# **Comments and Response Report**

The Proposed Construction of an Access Road, Residential Dwelling on Portion 216 of the Farm Uitzicht,
Brenton, Knysna

COMMENTS	RESPONSE
COMMENTS RECEIVED IN RESPONSE TO THE DRAFT BASIC ASSESSMENT REPORT – 3 September 2020 to 3 October 2020	
STATE DEPARTMENTS	
Forestry, Fisheries & The Environment (DFFE) – Melanie Koen – 30 Septe	mber 2020
<ol> <li>Forestry is responsible for the implementation and the enforcement of the National Forest Act (NFA), Act 84 of 1998 as amended and the National Veld and Forest Fire Act, Act 101 of 1998 as amended (NVFFA). Thank you for giving Forestry this opportunity to comment on above application.</li> </ol>	
<ol> <li>Forestry studied the supporting documents for the above-mentioned application and the following points related to Forestry's mandate i.e. the implementation of the NFA is applicable         <ul> <li>a. The above proposal still has to undergo a land-use planning application through the Knysna Municipality: Land-use Planning Section.</li> <li>b. Forestry will thus formally comment on the land-use application firstly before providing further comment to above application.</li> <li>c. Request that a more

Disturbed area adjacent to Kerk Laan suitable for development

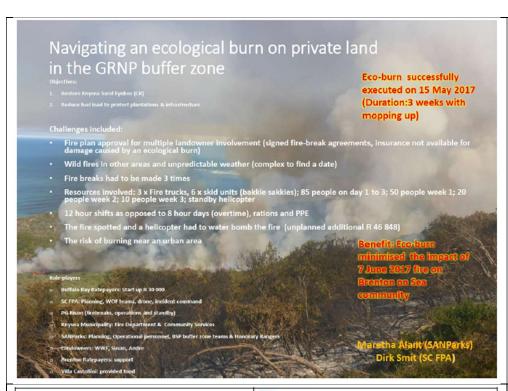
Development adjacent to Kerk Laan. Developing the main house in a
disturbed area adjacent to Kerk Laan with have the least negative impact
on biodiversity and landscape functionality. Other advantages are that
the drilling equipment and construction vehicles will have easy access to
the site via an existing road.

Noted. The preferred development plan has been amended to exclude the construction of a farm manager's residence in the northwestern corner of the property.

Development in the low lying area over the two sand dunes will compromise landscape functionality and set a bad precedent.

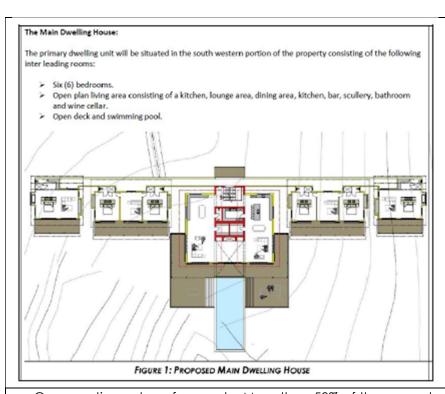
• Development in the low-lying area, over the two sand dunes or using the Campbell Road, will compromise landscape functionality and set a bad precedent. It will create fragmentation of a pristine coastal corridor.

Noted. The preferred development plan has been amended to exclude the construction of a farm manager's residence in the northwestern corner of the property.

FIGURE 1: PROPOSED MAIN DWELLING HOUSE

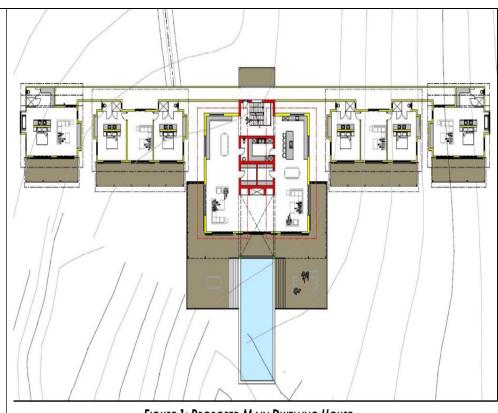
4.	The layout of the "main" dwelling appears to be more in line with the establishment of a boutique hotel or B&B. This has not been disclosed or stated as part of the intended use, however, if this EIA process recommends/approves the development based on the current level of disclosures then there must be an explicit condition prohibiting the use as a boutique hotel or B&B as the impact for such use has not been evaluated.	Noted. The preferred development plan has been amended to exclude the construction of a farm manager's residence in the northwestern corner of the property.  The development proposal entails the following:  (i) The construction of one main dwelling house to be situated in the south-western corner of the property (3000m²).  (ii)  The construction of a new internal road to provide access to the southern portion of the property.

6.	The disclosure on "managers dwelling" is extremely sparse with absolutely no indication of the number of rooms, provision for permanent staff/employees, vehicles etc and the associated usage impact cannot be fully assessed. The proposed size, essentially 1000 sqm for the "managers" dwelling raises concerns about the intended or non-disclosed usage.	Noted. The preferred development plan has been amended to exclude the construction of a farm manager's residence in the northwestern corner of the property.  The development proposal entails the following:  (i) The construction of one main dwelling house to be situated in the south-western corner of the property (3000m²).  (ii) The construction of a new internal road to provide access to the southern portion of the property.

- (i) The construction of one main dwelling house to be situated in the south-western corner of the property (3000m²).
- (ii) The construction of a new internal road to provide access to the southern portion of the property.
